The City of Lewes

STAFF REVIEW

FEBRUARY 7, 2019

Application Title	Fishers Cove
Application Type	Preliminary Consent - Major Subdivision
Owner	Burke & Rutecki, LLC
Tax Map and Parcel	SC Tax Map# 335-4.14-100.00, 115-4.14-1.03, 335-4.00-15.00
Size and Location	12.06 acres and located off Rodney Avenue, southwest of Pilottown Road
Comprehensive Plan Designation	Residential
Zoning District	R-2 – Residential Low-Density
Present Use	1 residential dwelling and agriculture/vacant
Proposed Use	18 additional residential dwellings
Online application material	https://lewescommissions.wordpress.com/reviews/dev_reviews/fishers-cove/

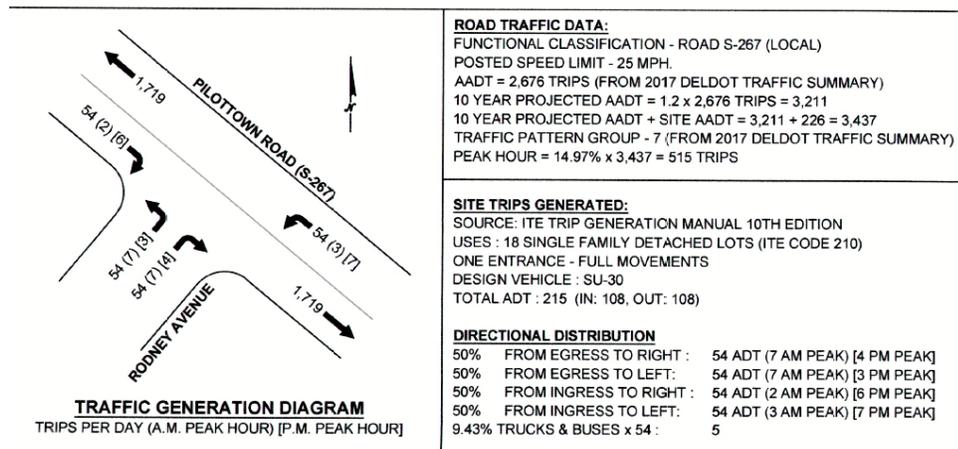
the new roads to City standards using a 50' ROW comprised of 2 travel lanes (16' lanes), with curbs/gutters and 5' sidewalks on each side along with 3' unpaved section between the sidewalks and curbs (see typical roadway section below).

The applicant has also noted in the plan a possible option to allow the pavement width to be reduced to 24' by reducing cartways to 12' pending recommendation by the Planning Commission and approval by City Council (Section 170-27). Decisions regarding residential road widths typically involve balancing the need to accommodate vehicular traffic or providing opportunity for on-street parking (if needed) while avoiding concerns related to excess impervious cover or making wide roads that tend to increase vehicle speed.

The proposal to use an extension of Rodney Avenue as the access to the proposed development triggers evaluations of that existing corridor. Preliminary evaluations indicate that Rodney Avenue is currently not constructed to City standards. The paved width is estimated to be less than 20' and narrower in several stretches. The City Engineer also suggests that road and base is also not built to current standards which could degrade rapidly should it be used to accommodate heavy equipment that would be expected with site development. As part of the application the applicant has proposed 3 alternatives intended to improve Rodney Avenue to enable it to accommodate the additional traffic which are listed under #2 of the notes in the Typical Road Section image above.

TRIP GENERATION - PILOTTOWN ROAD (S-267) AND RODNEY AVENUE

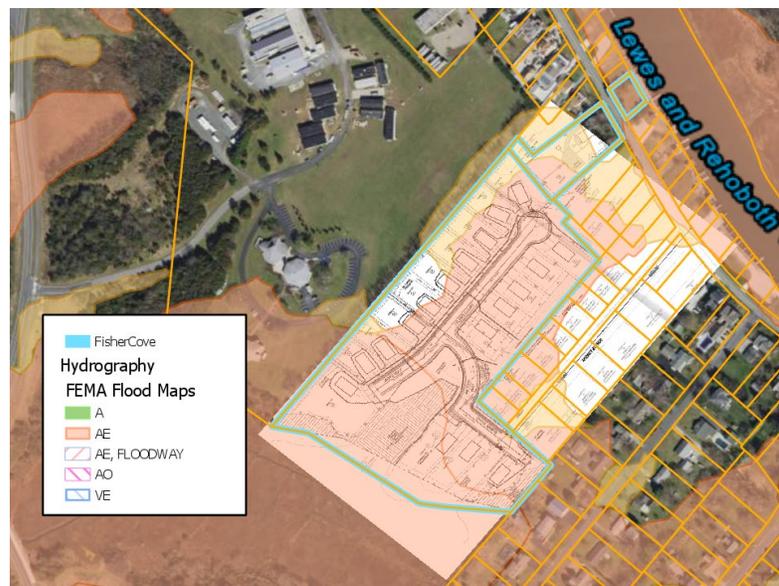
Included within the plan application is a panel that describes traffic generation and distribution. The information indicates that the development would result in an additional 215 average daily trips per day. As suggested in the panel distribution of the current and additional traffic (estimated to be 500 average daily trips), at the intersection of Rodney Avenue with Pilottown Road, would be evenly split (see Trip Generation image below).
